## **Report to the Future Melbourne Committee**

Planning Permit Application: TP-2022-195 186-190 Lygon Street, Carlton

# PLANNING PERMIT APPLICATION DELEGATE REPORT

Figure 9 - Original (left) and revised (right) Ground Level Plan extract showing the Lygon Street interface. From Drawing A1.01

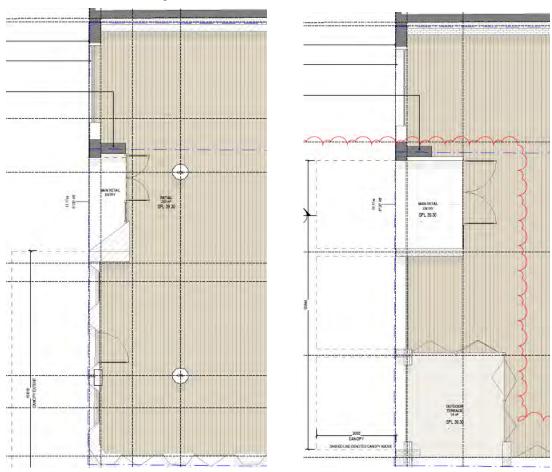
Additionally, the revised design also increased the rebate between the retained heritage building and the adjacent new building from 1.35 to 2.54 metres (refer to Figure 9). As noted by Council's Heritage Advisor, this is also considered to be at-odds with the prevailing Lygon Street streetscape character, where alcoves and rebates are limited. A condition on any permit issued will therefore require the size of the rebate at street level to be reduced to one metre, and the rebate at level 1 deleted, in accordance with the heritage advice.

Figure 10 - Level 1 plan showing roof terrace above the retained heritage building. From Drawing A1.03

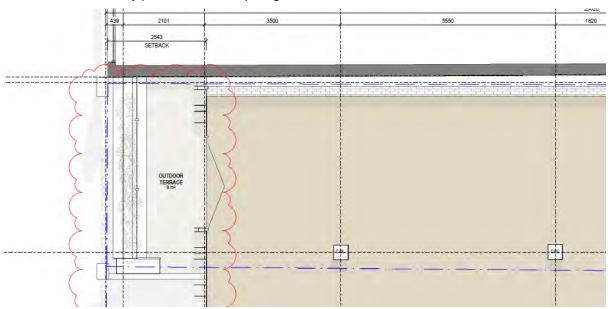
The creation of a terrace, together with associated balustrades and landscaping above the retained heritage façade would serve to highlight the extent of demolition and may give the impression of 'façadism'. The roof terrace is not considered to be essential to achieve an acceptable level of amenity for building occupants, given the access to a communal roof terrace. For that reason, a further condition will be included on any permit issued, requiring the deletion of the roof terrace.

Figure 14 - East Elevation of the proposed development showing solid walls on the northern half of the interface. From Drawing A2.01

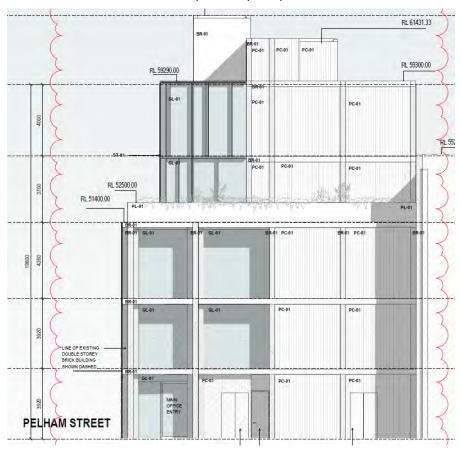
The secluded private open space to the rear of 66 Pelham Street is located approximately 10.5 metres from the north-eastern corner of the proposed building. As depicted in the East Elevation reproduced at Figure 14, this interface is characterised by solid walls, which would prevent direct views into this area of secluded private open space.
